Detailed Site Plan

DSP-99006-01

| Application | General Data | |
|--|------------------------------|---------------|
| Project Name: McDonald's-Hyattsville Location: South side of East-West Highway (MD 410) at its intersection with Toledo Terrace. Applicant/Address: McDonald's Corp. 6903 Rockledge Drive Bethesda, MD 20817 | Planning Board Hearing Date: | 04/25/13 |

SUBJECT: Detailed Site Plan DSP-99006-01
Type II Tree Conservation Plan TCPII-046-99-01
McDonald's-Hyattsville

RENDERED LANDSCAPE PLAN

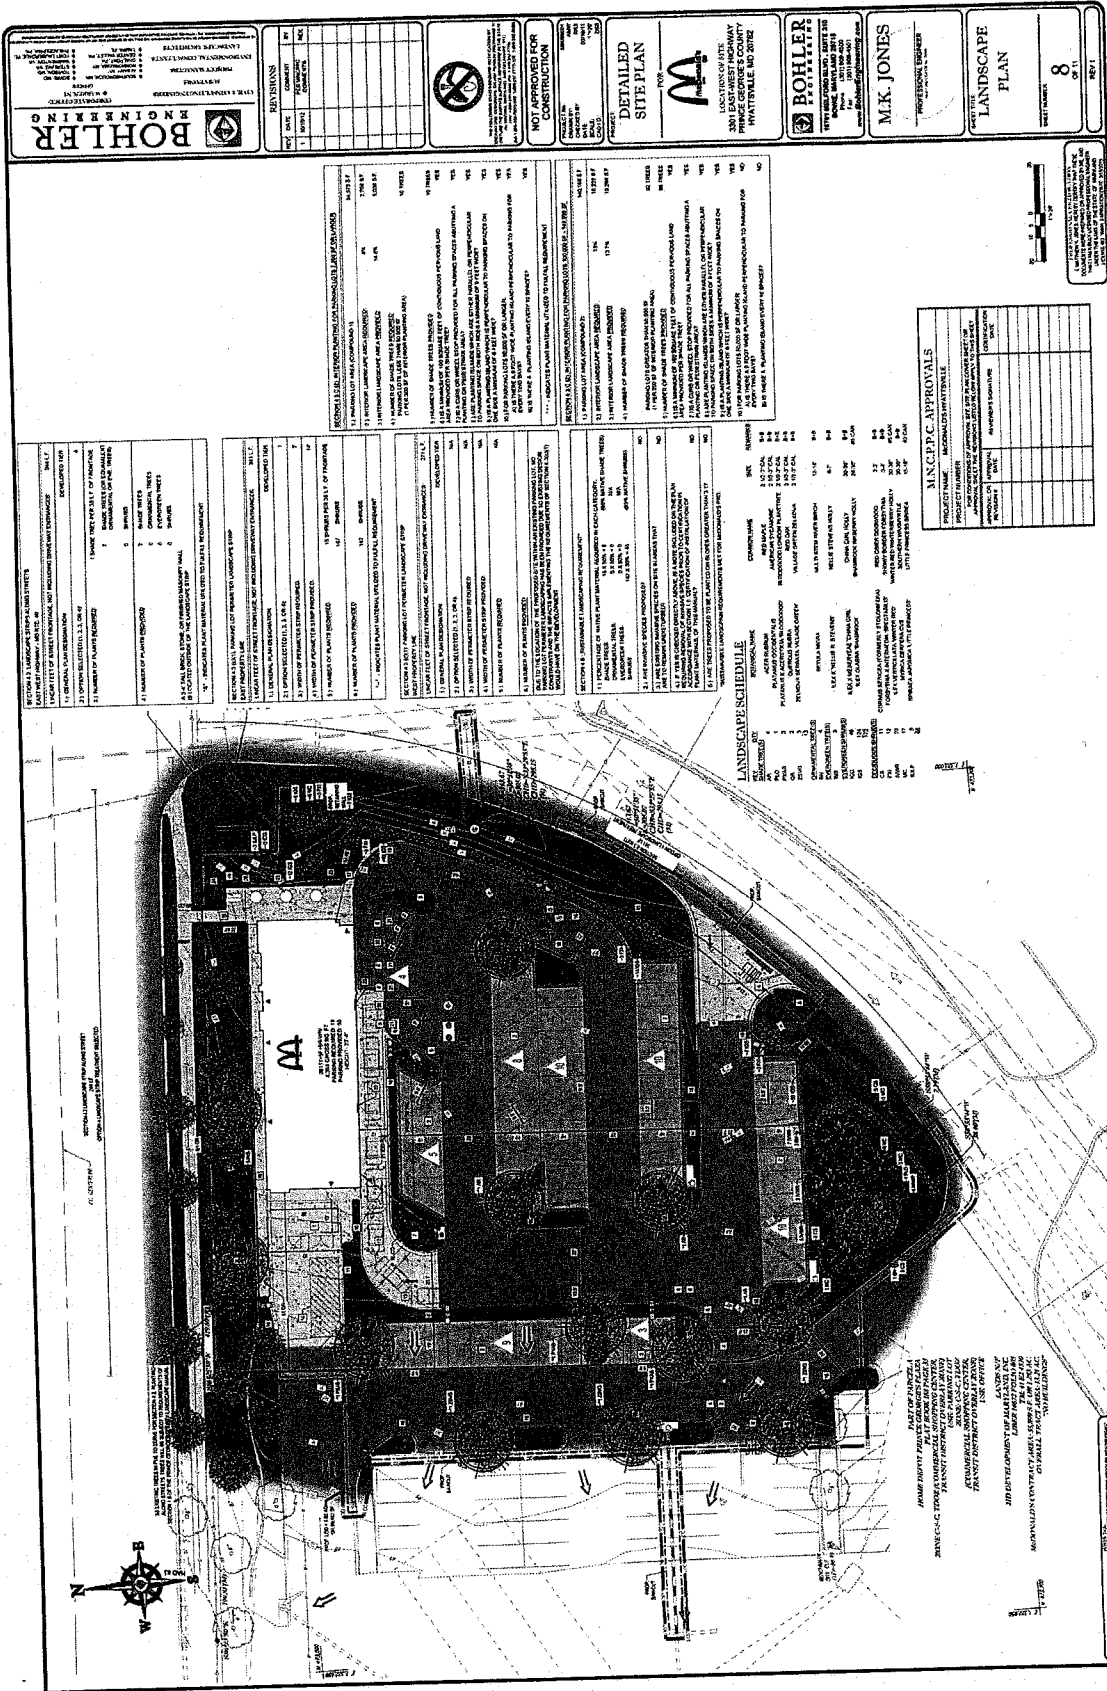
Regarding Section 4.3(c)(2), Parking Lot Interior Planting Requirements, the landscape plan provides the correct schedule for the two different compounds on-site. However, there are several inaccuracies in the schedules that should be corrected, including the schedule not matching the one in the Landscape Manual (see 7. and 10. b) and the number of trees required should be calculated based on the provided interior planting area. This means that Parking Compound 1 is short of the required number of shade trees

and additional trees should be added. Additionally, the schedule for Parking Compound 2 shows the requirements being met; however, no plan was provided showing this. These issues have been included in conditions of approval in the Recommendation Section of this report.

- e. **Section 4.9, Sustainable Landscaping Requirements**—This DSP application is subject to Section 4.9, which requires that a percentage of the proposed plant materials be native plants. However, the number of plants in the schedule does not match the plant schedule and the plant schedule does not designate which plants are native species. These issues should be revised on the DSP prior to certification.

- f. Remove the Section 4.3(c)(1) Parking Lot Perimeter Landscape Strip schedules from the DSP.
- g. Revise the Section 4.3(c)(2) schedules to match the one in the 2010 *Prince George's County Landscape Manual* (Landscape Manual) and to accurately reflect the required number of shade trees, and that requirement being met. Additionally, provide a landscape plan for the entirety of Parking Compound 2.

Drive-Thru Side Elevation

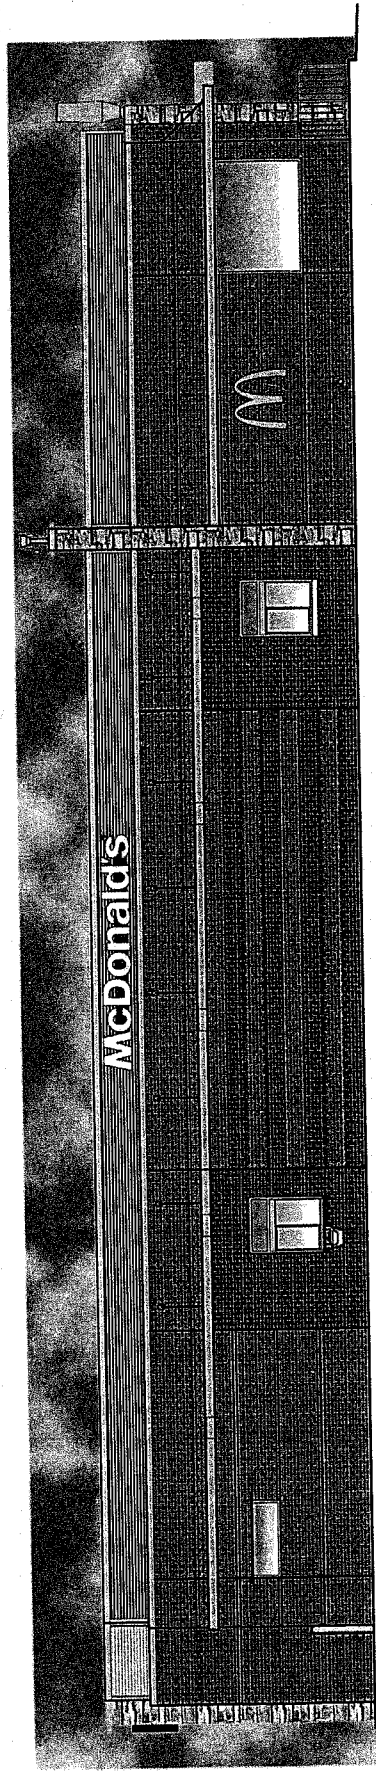
Although the planned configuration of the McDonald's is less suburban and promotes a more pedestrian-friendly environment, staff finds any potential amendment to the development plan to permit drive-through service would be detrimental to the transit district goals and desired development pattern. However, should this application be amended or conditioned to preclude the drive-through component the proposed restaurant

These operational issues provide another justification for the elimination of the drive-through service. Given the site constraints, the plan would be much more functional for all users, including delivery vehicles, if drive-through service were eliminated on the plan. Beyond these issues, the site plan is acceptable. Access is acceptable.

In summary, the Transportation Planning Section finds that the subject application does generally conform to the 1998 *Approved Transit District Development Plan for the Prince George's Plaza Transit District Overlay Zone* (TDDP) and other prior approved plans. It is determined that while the use is acceptable at this location, the provision of the drive-through service (a) poses issues with the TDDP and the general goals of the T-D-O Zone, (b) is not consistent with excellent TOD, (c) creates conflicts with patrons entering the building, and (d) results in queuing issues affecting vehicles entering and leaving, and should be eliminated from the plan.

1. Prior to signature approval of the plans, the applicant shall revise the detailed site plan or provide additional information as follows:
 - a. Revise the DSP to remove the drive-through portion of the use and convert the area into green space or amenity space.
 - b. Revise the DSP to show an expanded paved area in the front of the restaurant, to the east, to include specialty paving, tables and chairs for customer use and decorative plantings.
 - c. Submit a copy of an approved Stormwater Management Concept plan and letter consistent with the proposed layout.
 - d. The sidewalk connecting the McDonald's to the streetscape along East-West Highway (MD 410) shall be revised to provide special paving to be approved by the Urban Design Section as designee of the Planning Board.
